2005 Annual Report

Shepley's Hill Landfill Long Term Monitoring & Maintenance Devens, Massachusetts

**EPA Comments on
Draft 2005 Annual Report
Shepley's Hill Landfill
Long Term Monitoring & Maintenance
Devens, Massachusetts
December 2006**

Re: Draft 2005 Annual Report
Shepley's Hill Landfill
Long Term Monitoring & Maintenance
Devens, MA
December 2006

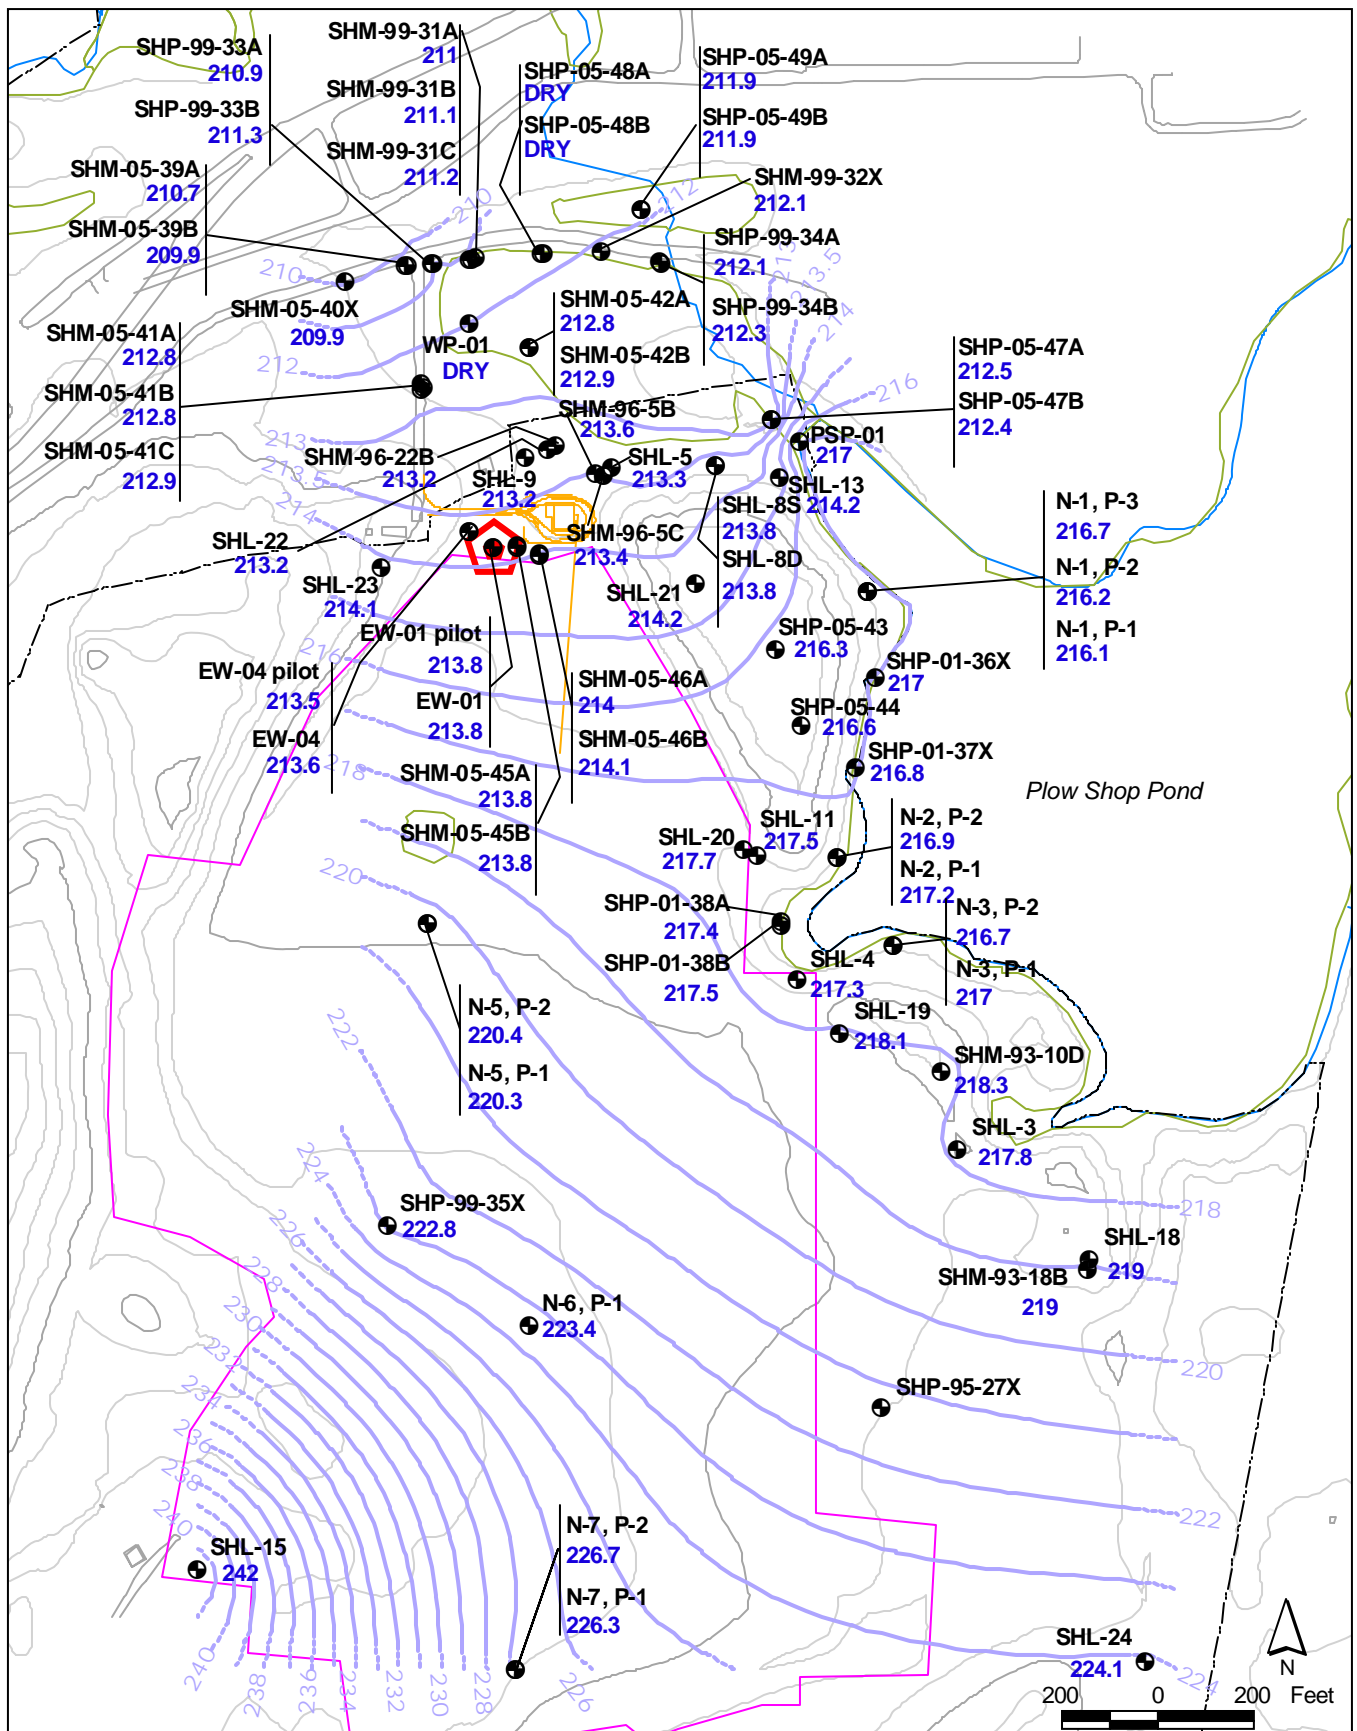
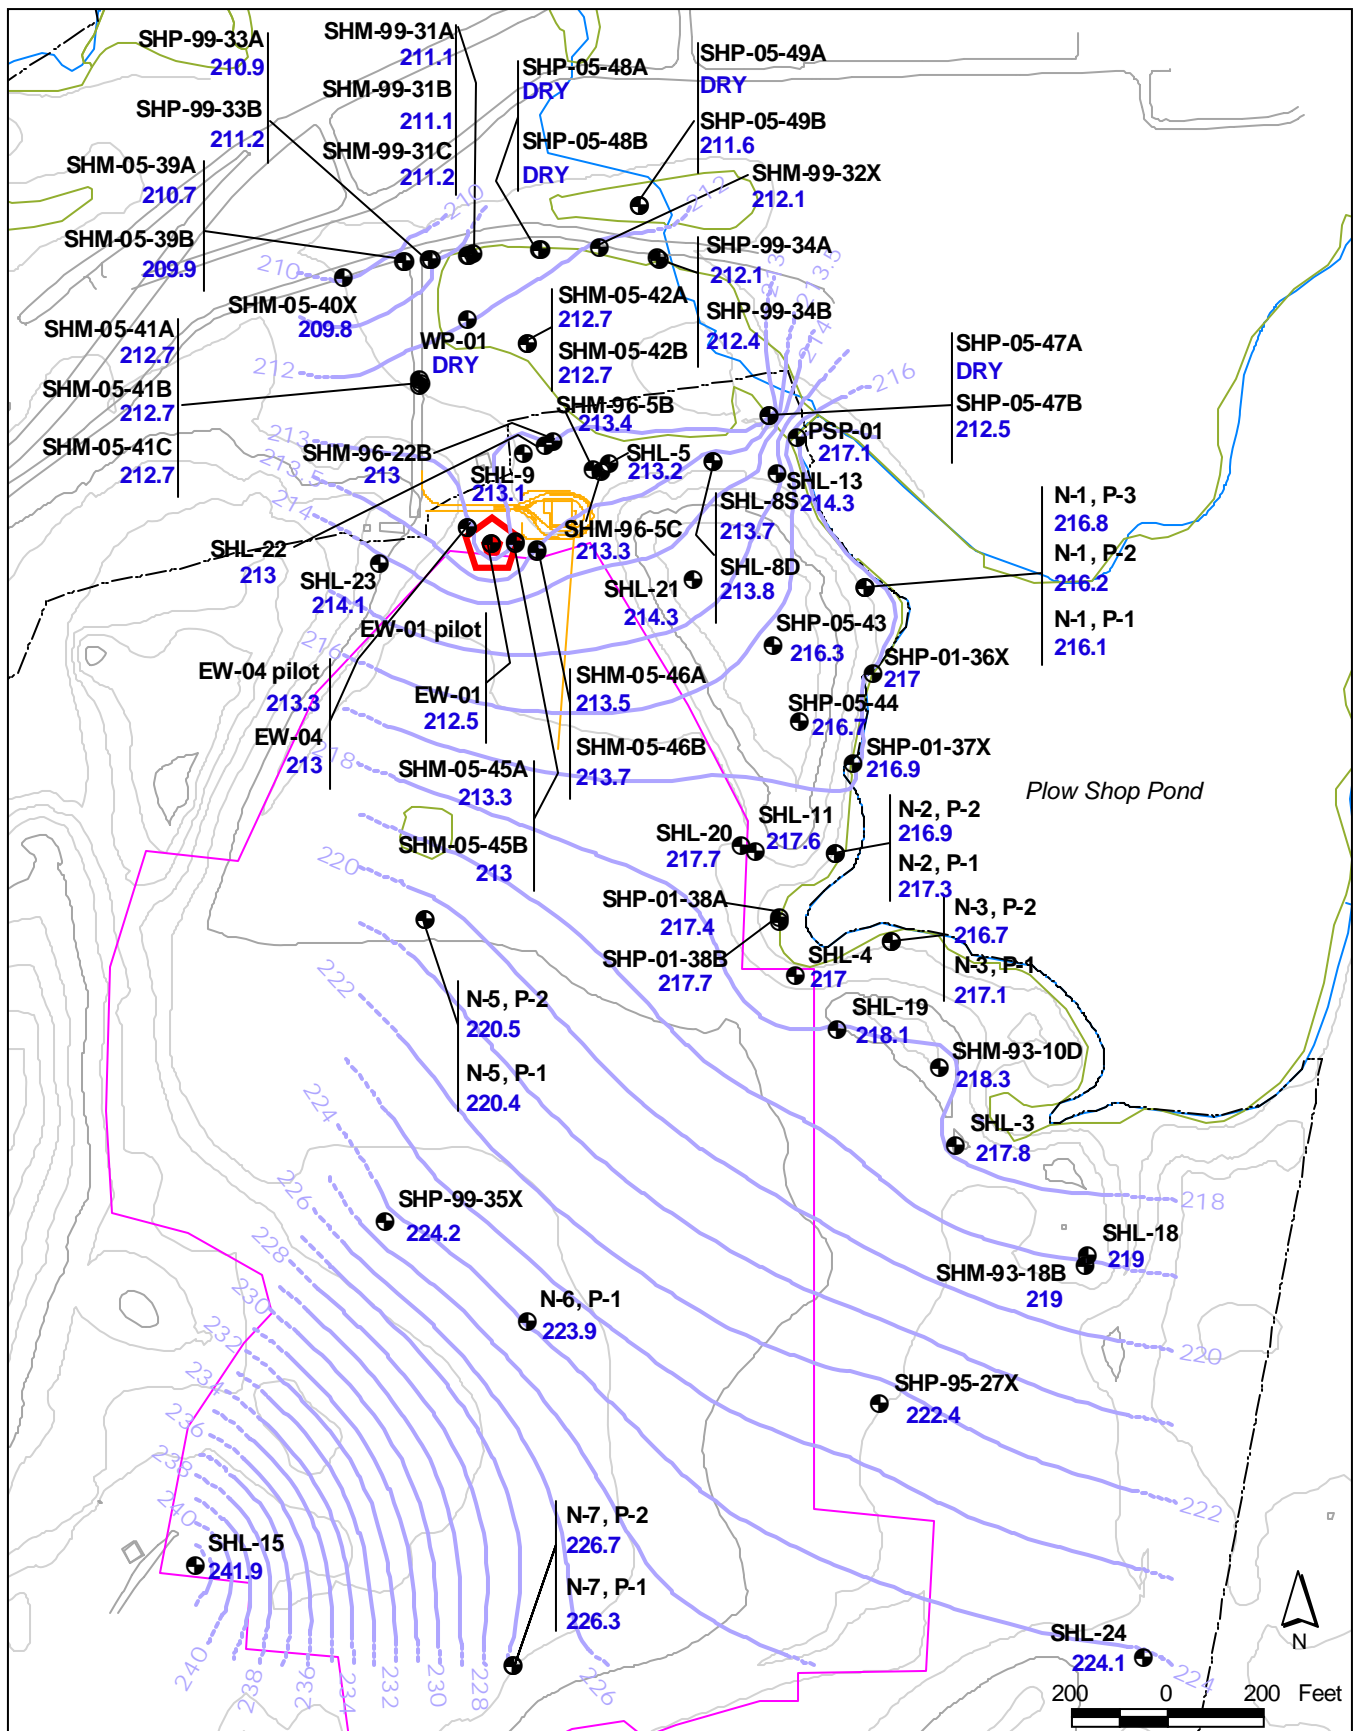
5. Section 5.0, Page 7: Water-level measurements taken during August 2006 confirm the general northerly direction of groundwater flow in the overburden. The last sentence in this

section suggests that results of the extraction test indicate "...that the operation of the groundwater extraction system will create an even greater northerly flow." Comparison of groundwater elevation contours on Figures 5-1 and 5-2 shows essentially no difference in the direction of groundwater flow, except in the immediate vicinity of the extraction wells. Please either explain what is meant by "...even greater northerly flow" or delete this statement.
